UNITED STATES PATENT AND TRADEMARK OFFICE

APPLICATION NO.	FILING DATE	FIRST NAMED INVENTOR	ATTORNEY DOCKET NO.	CONFIRMATION NO.
10/603,126	06/23/2003	Scott Seamans	40130-050100	9833

Office Action Summary

DETAILED ACTION

Fig. 1

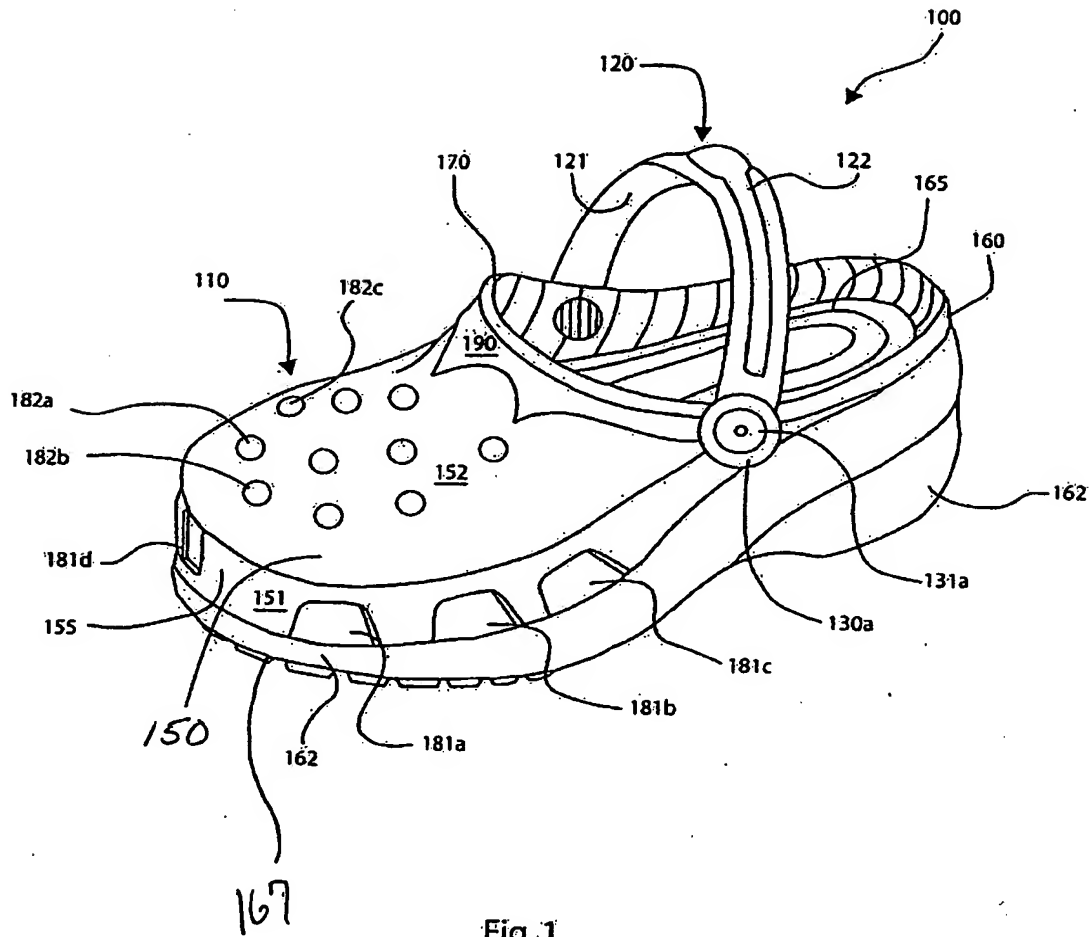
The attached replacement sheets include changes made in Figs. 1, 3 and 5 and replace the original sheets containing those drawings. In Fig. 1, element 156 has been changed to 150 and previously omitted element 167 has been added. In Fig. 3, previously omitted element 166 has been added. In Fig. 5, previously omitted element 168 has been added.

Approved for entry.
05-12-05
